ADDENDUM

December 15, 2017

RFB NO. 317028 - ADDENDUM NO. 1

SCHUMACHER BARN REMODEL/SITE IMPROVEMENTS (REBID)

1 LOWER ATTIC PLAN - ELECTRICAL
1/4" = 1'-0"

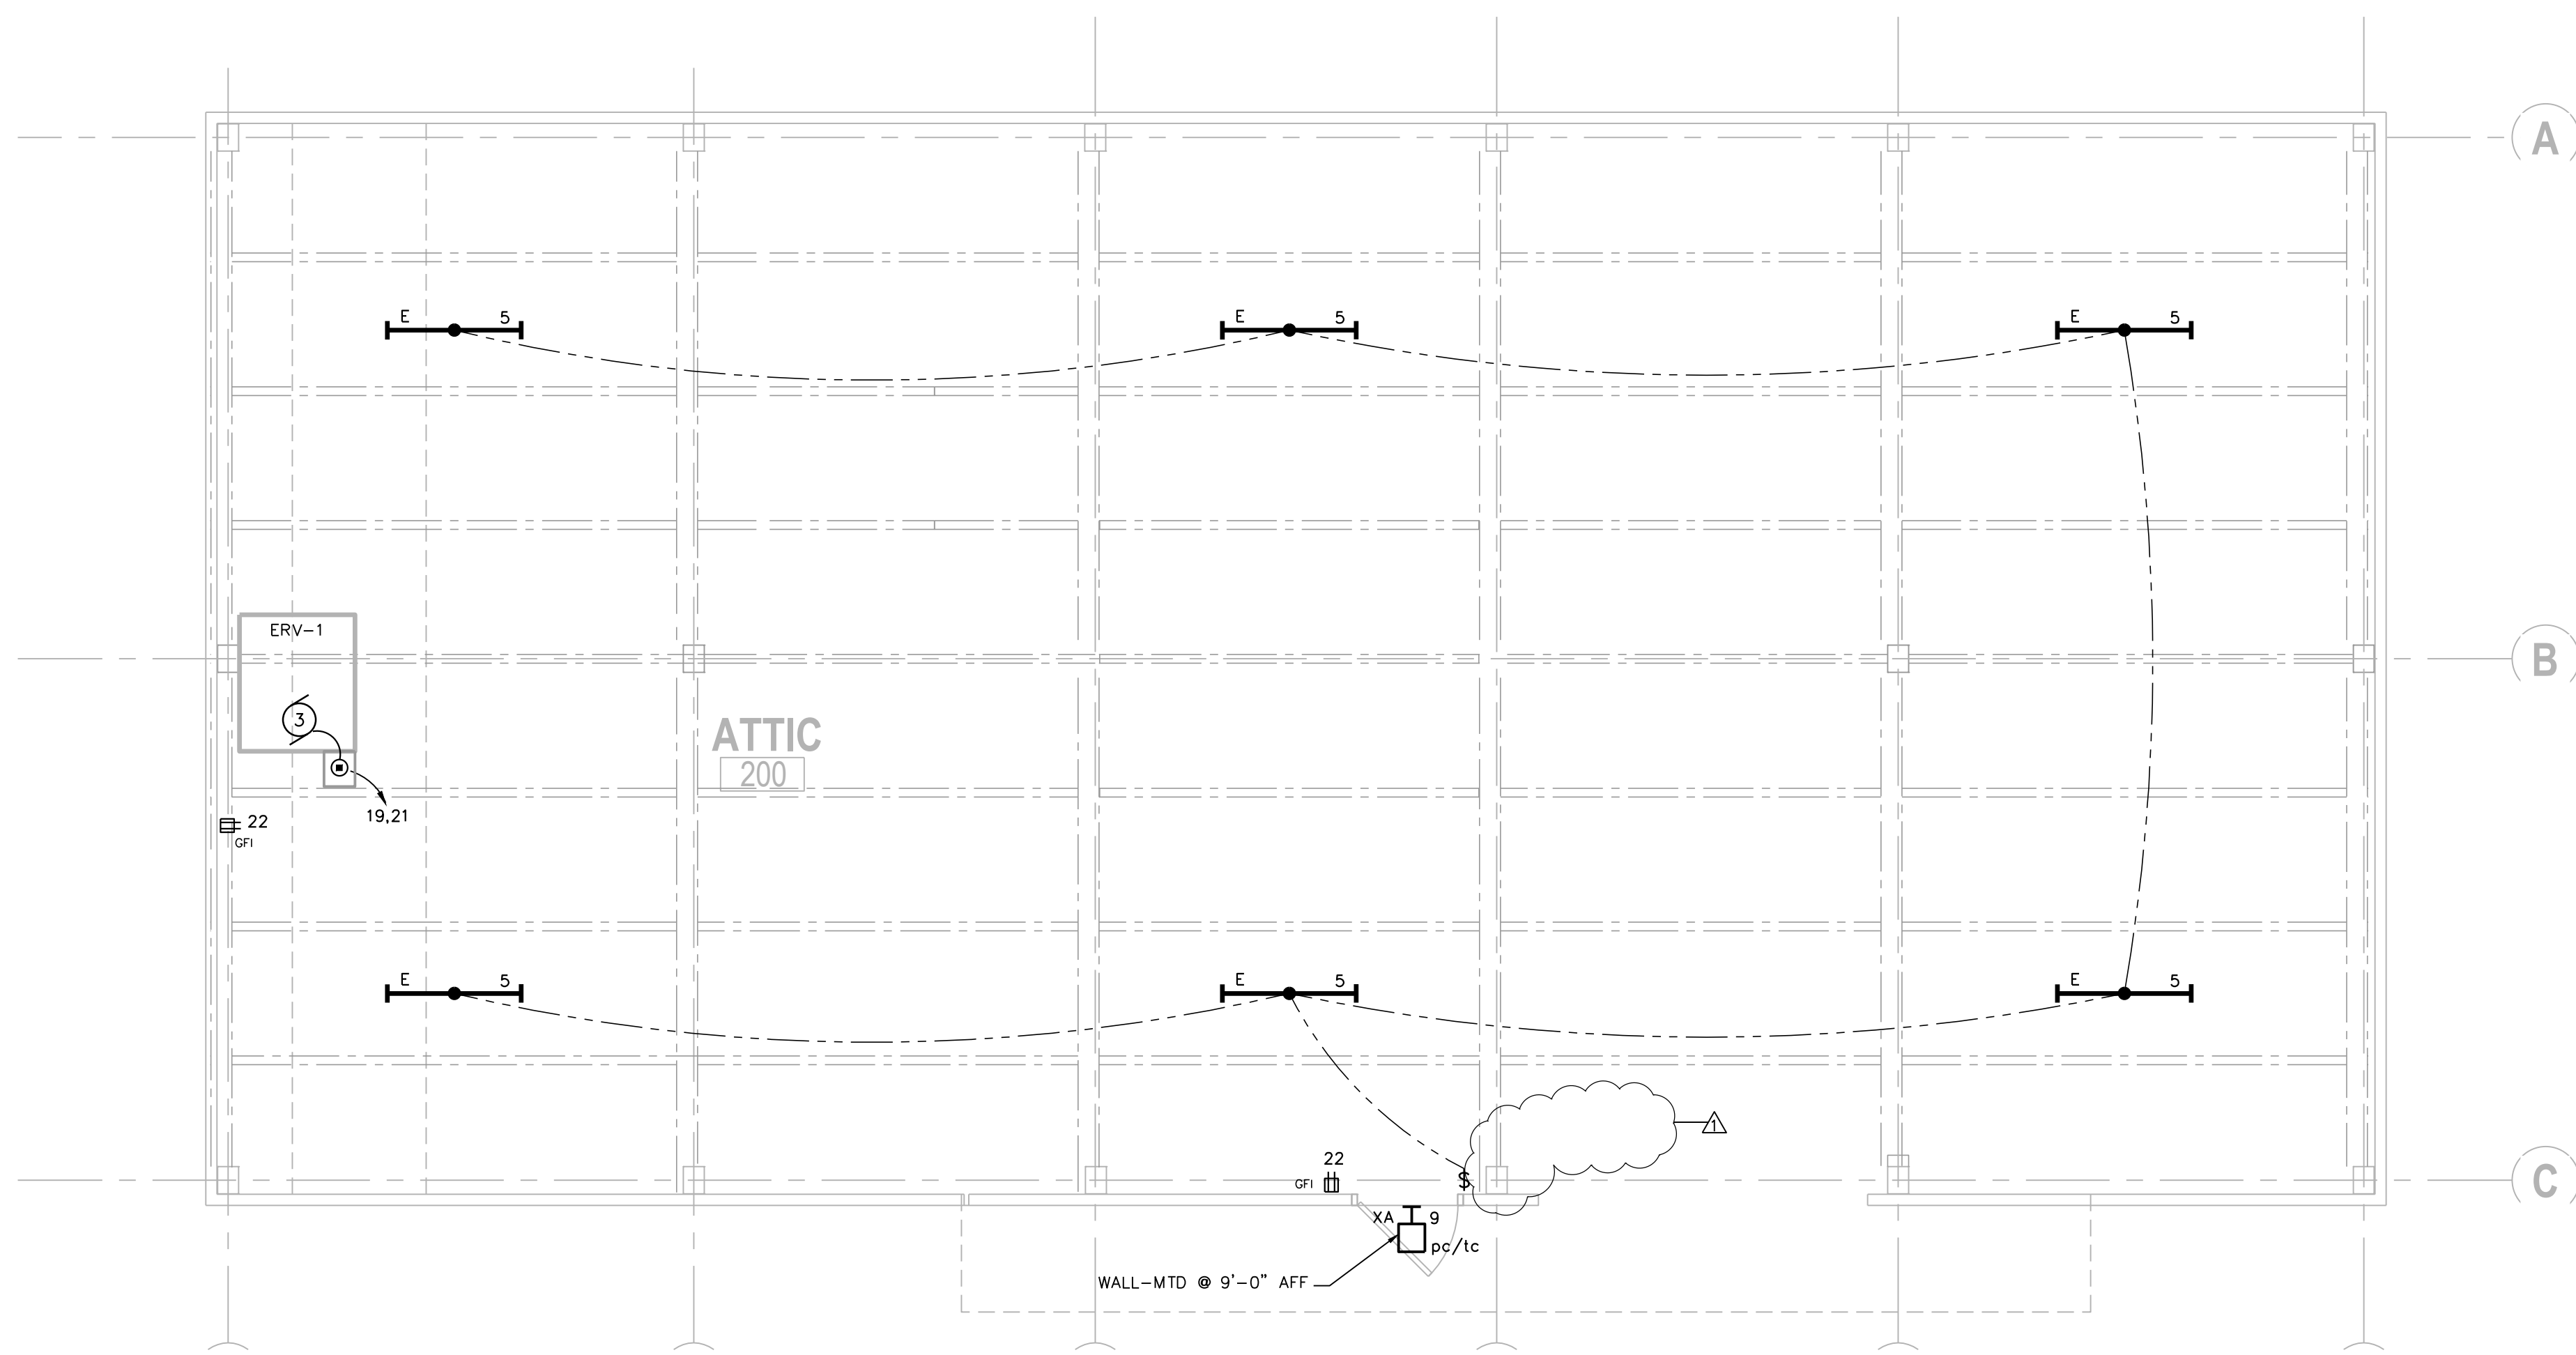
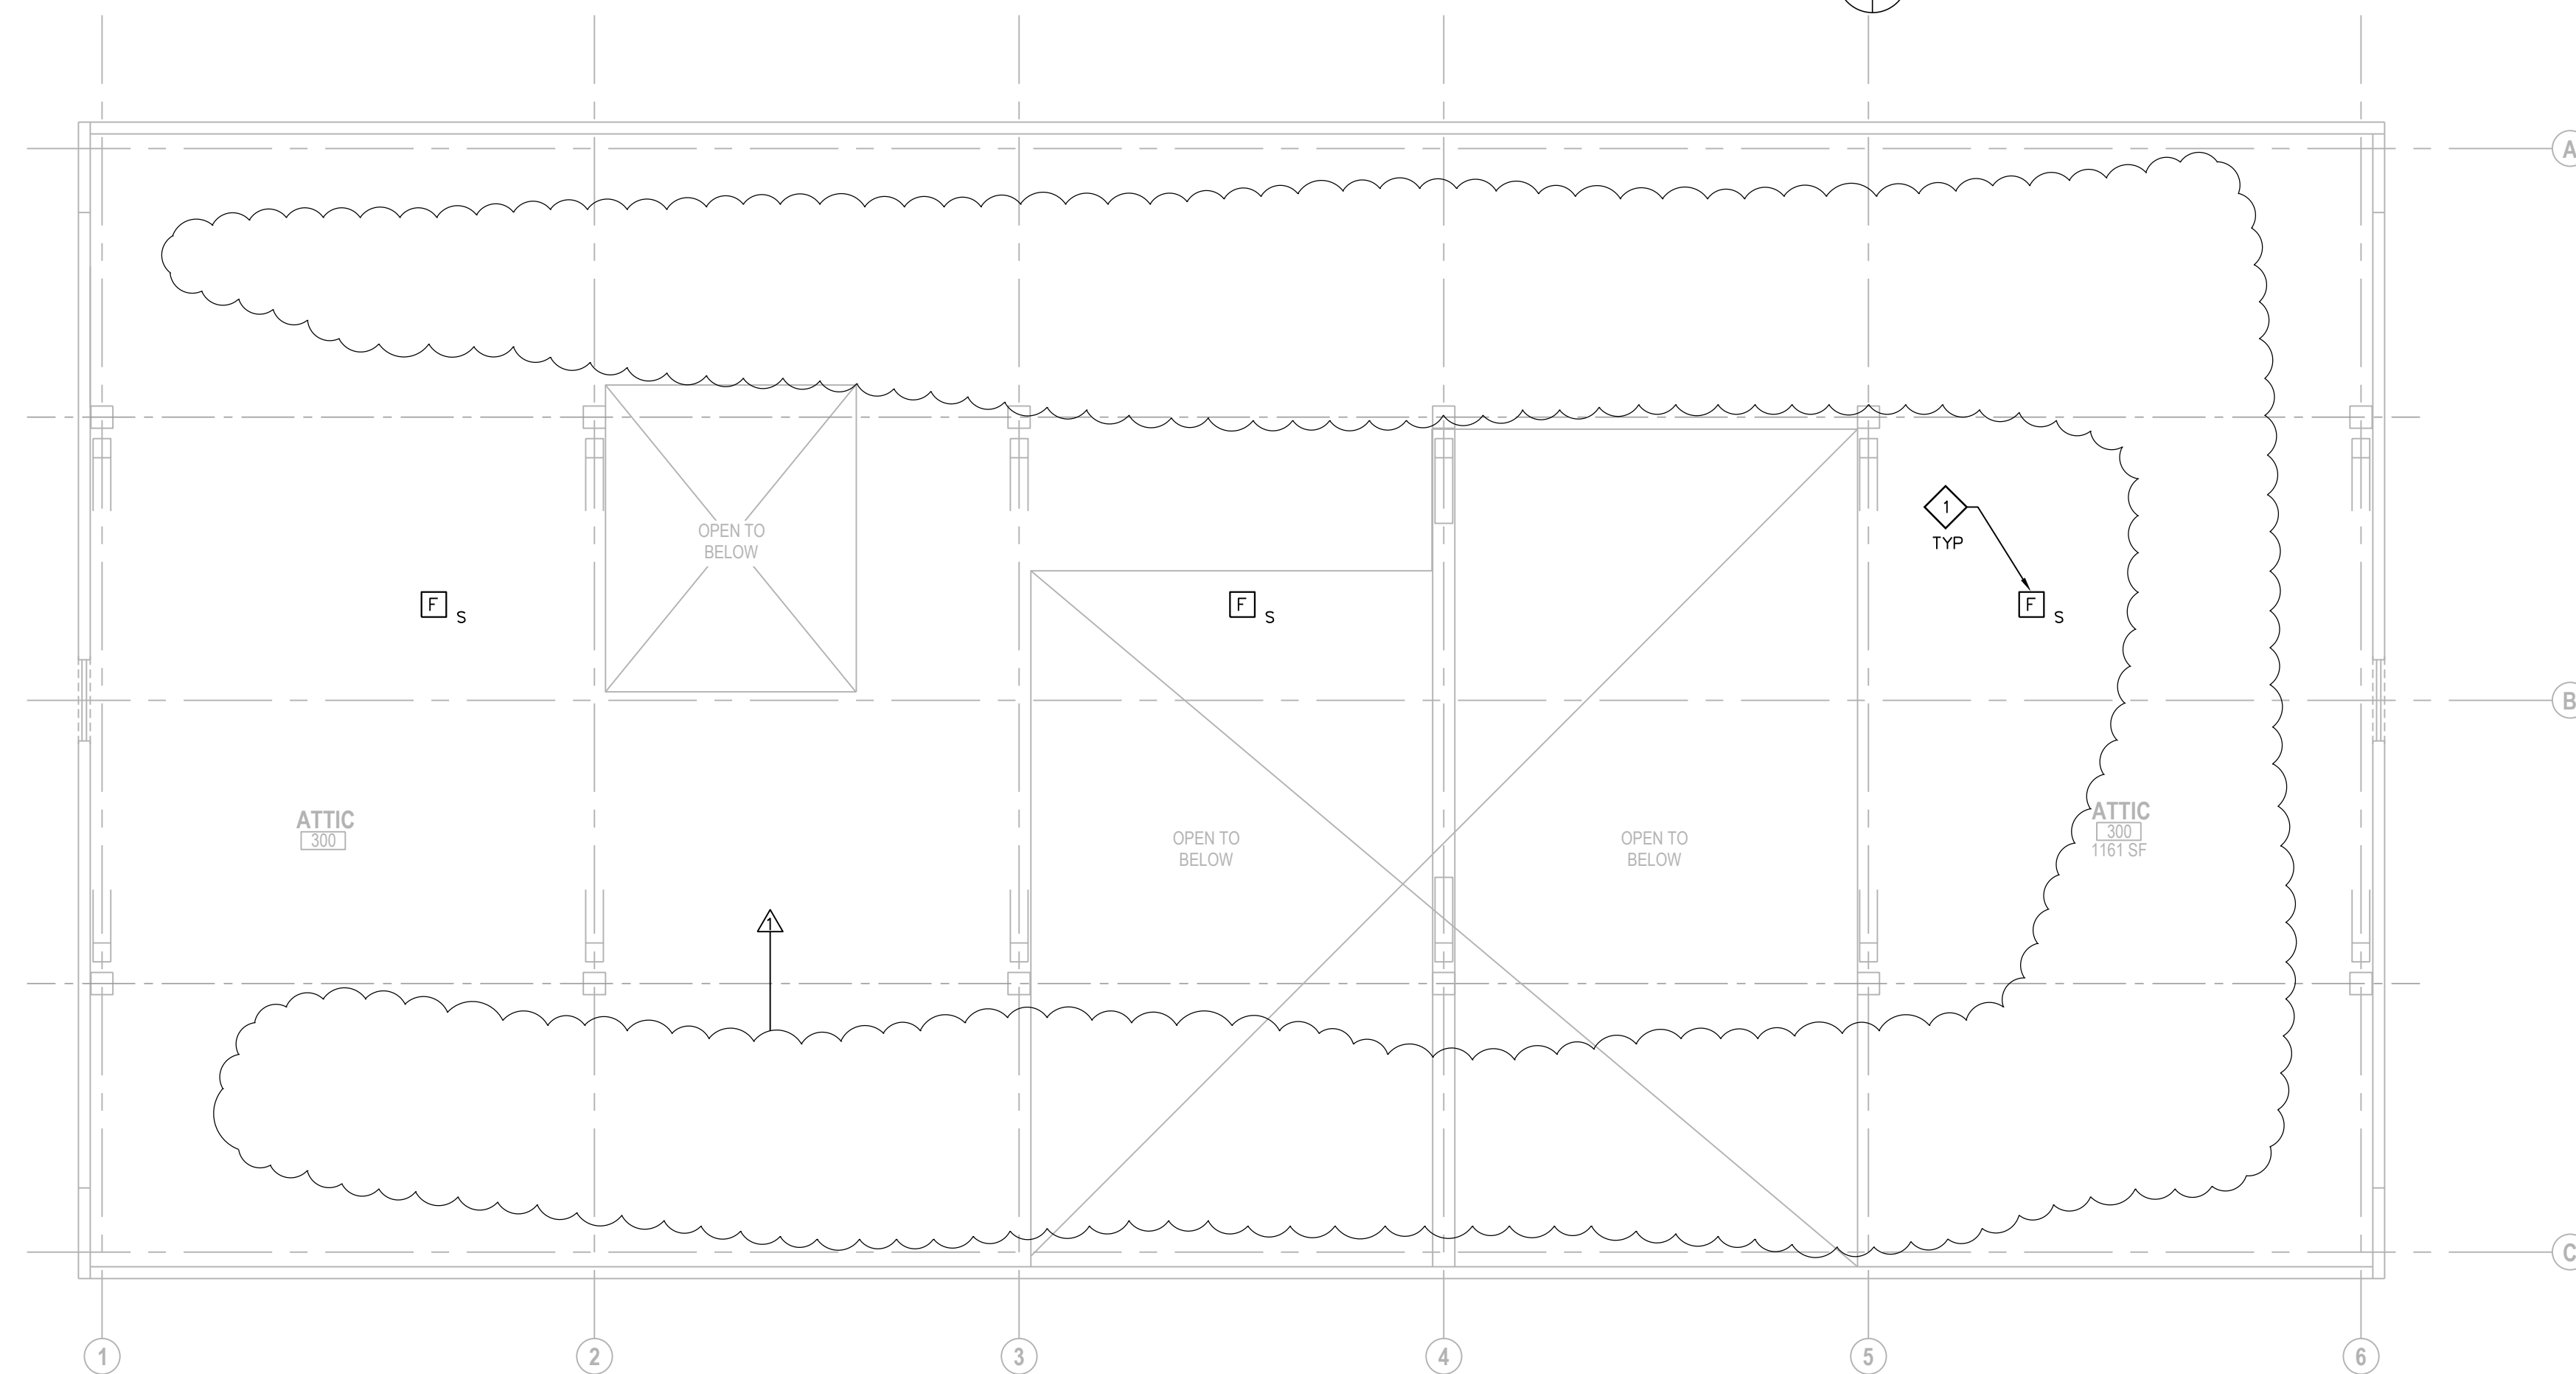
33. Sheet E1.2 - ATTIC FLOOR PLANS - ELECTRICAL

Delete current Sheet E1.2 and replace with new Sheet E1.2, issued with this Addendum.
Deleted upper attic lights and associated switch.

**ELECTRICAL
DETAILS**

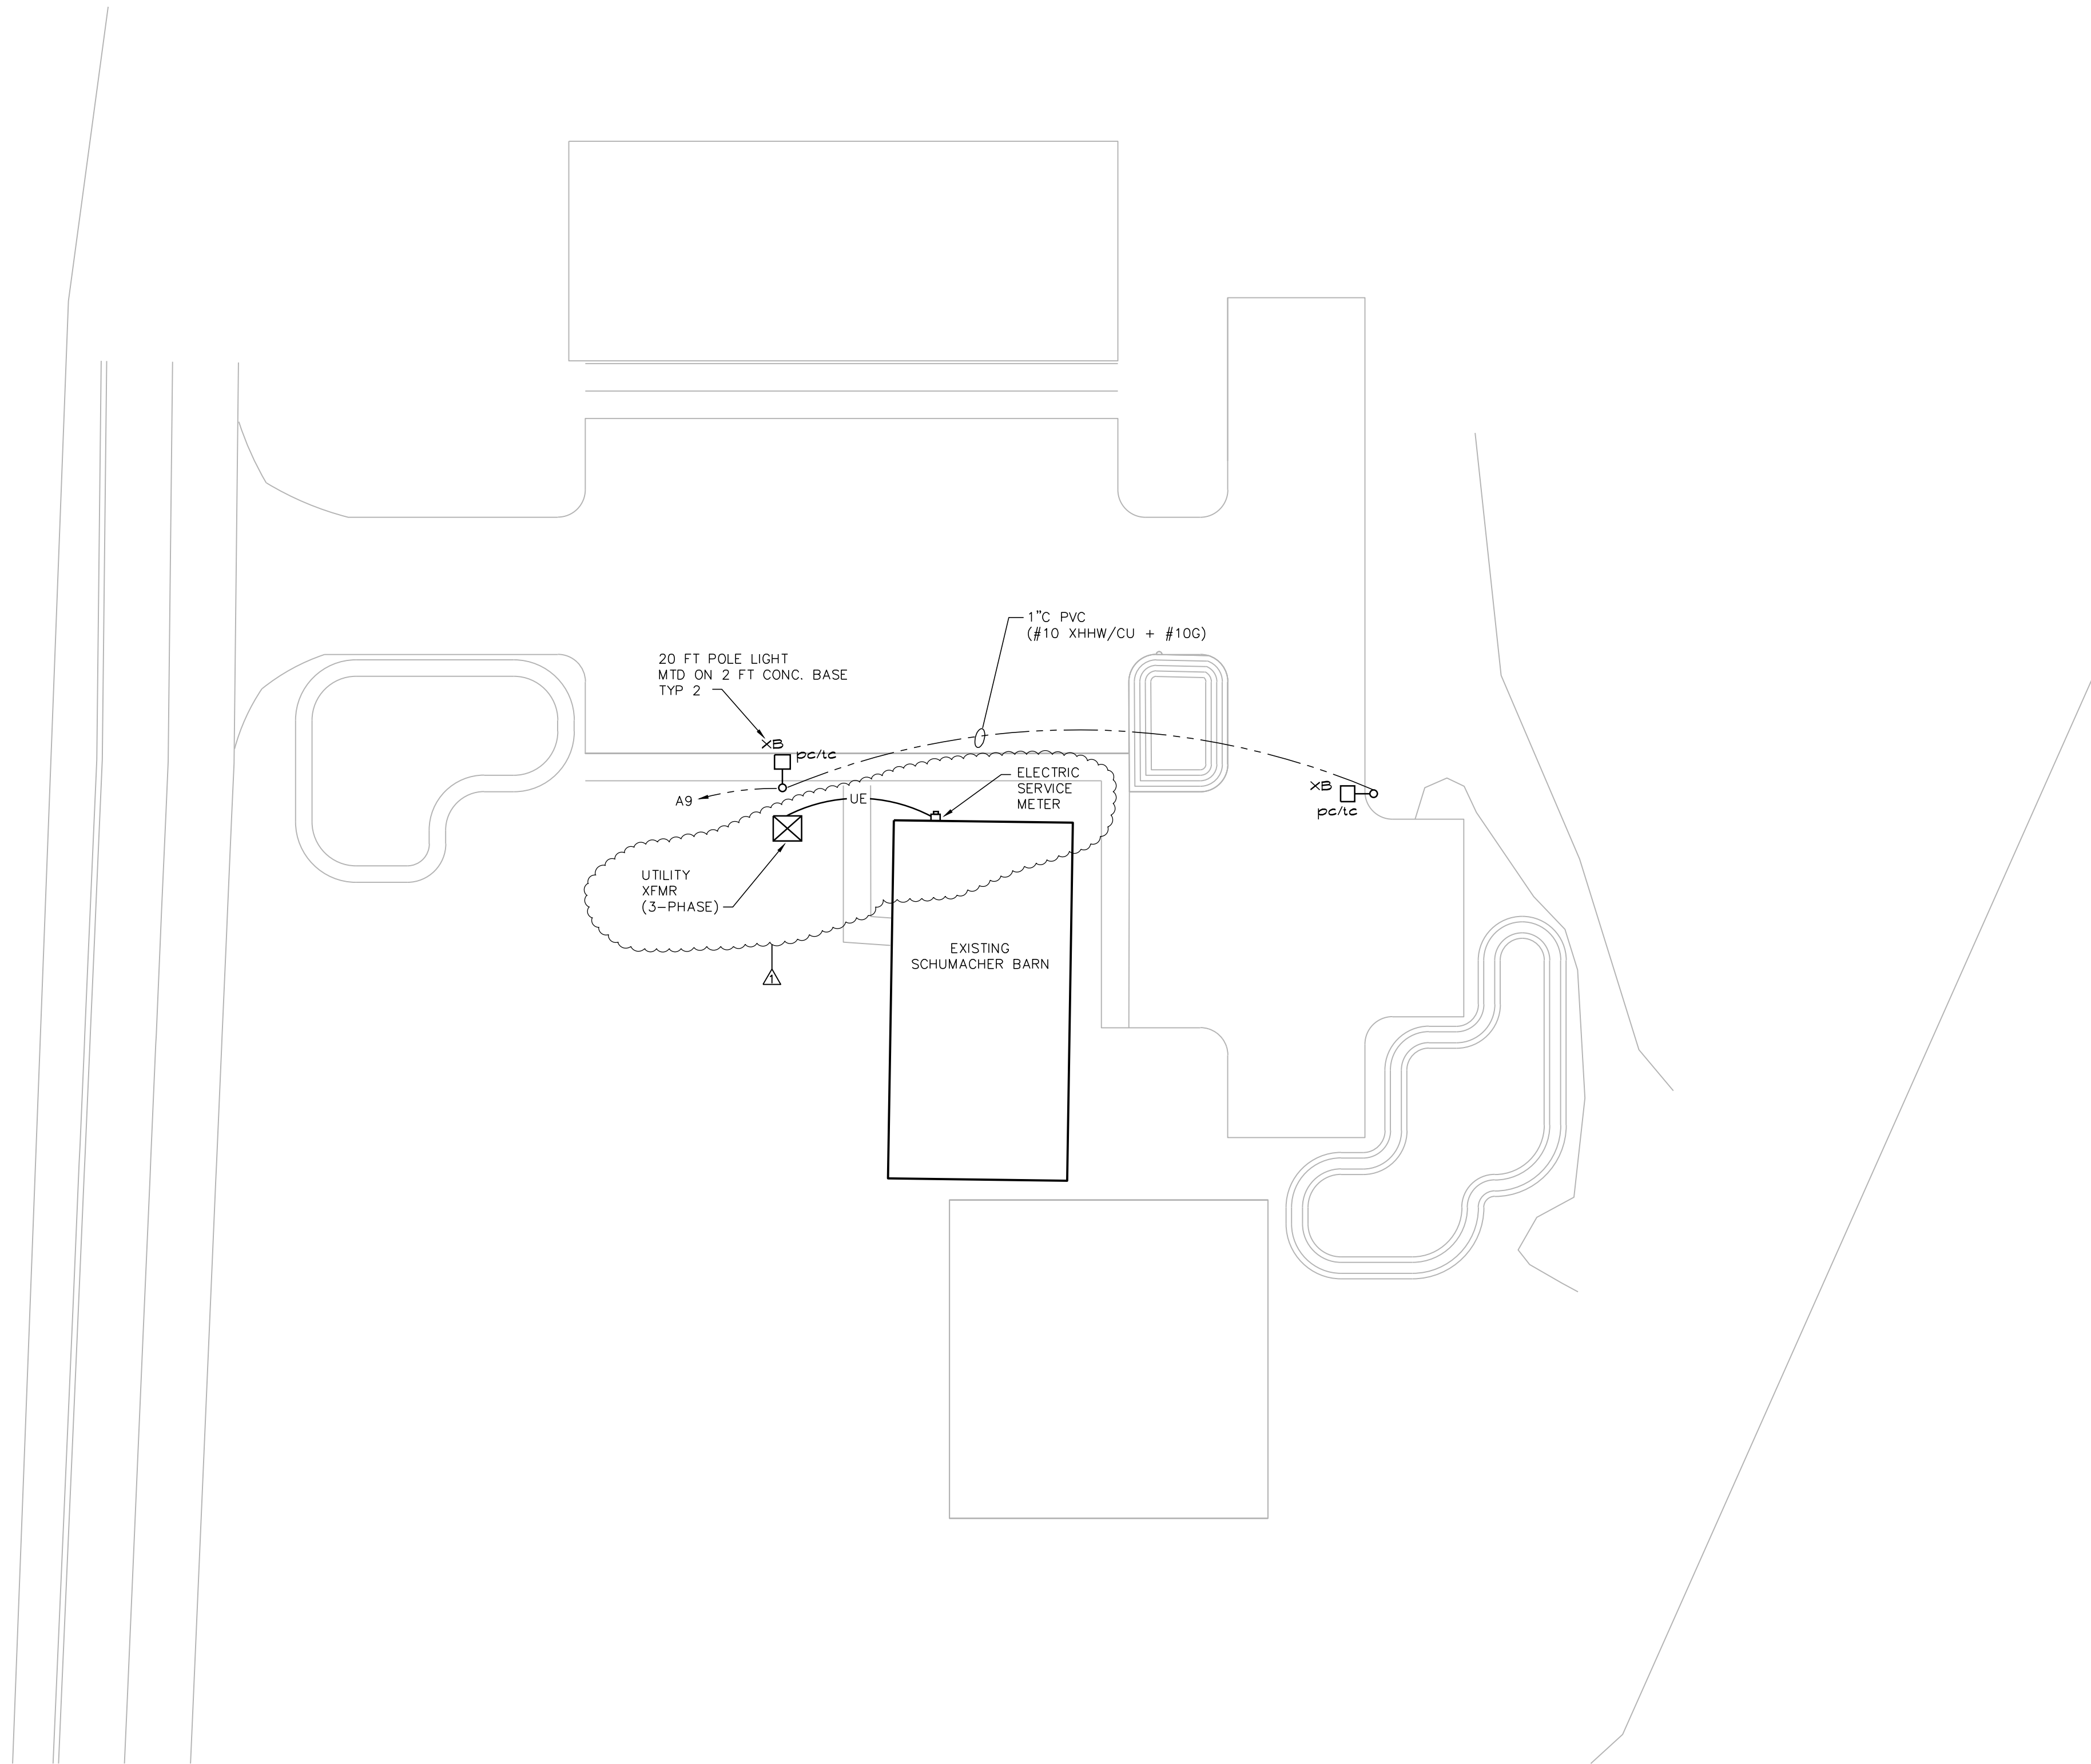
35. Sheet E3.0 - ELECTRICAL DETAILS

Delete current Sheet E3.0 and replace with new Sheet E3.0, issued with this Addendum.
Modified electric riser for 3-phase with fire pump feeder.

1 SITE ELECTRICAL PLAN
1" = 20'-0"

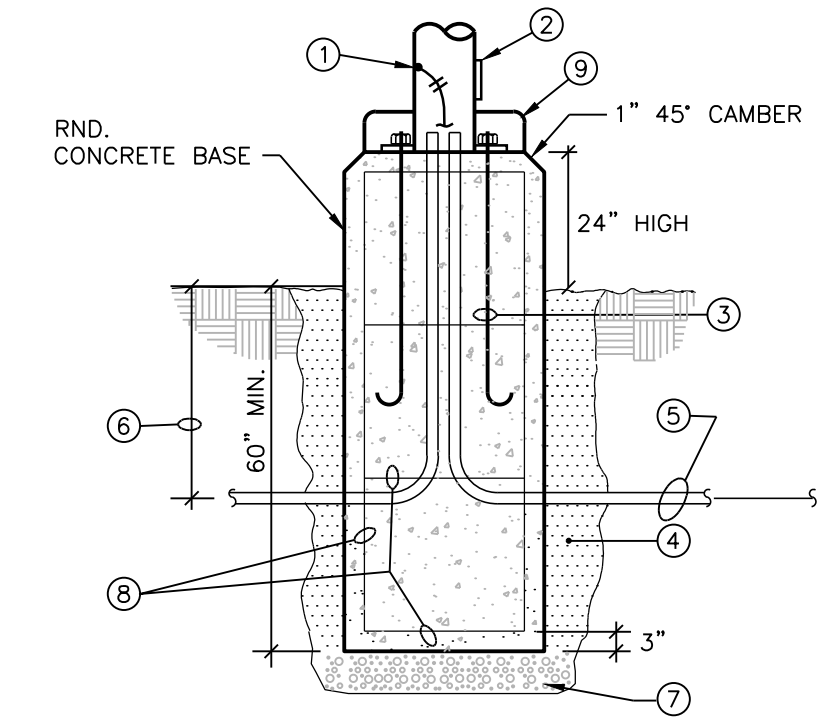
36. Sheet SE1.0 - SITE ELECTRICAL PLAN

Delete current Sheet SE1.0 and replace with new Sheet SE1.0, issued with this Addendum.
Added new transformer location and new meter location.
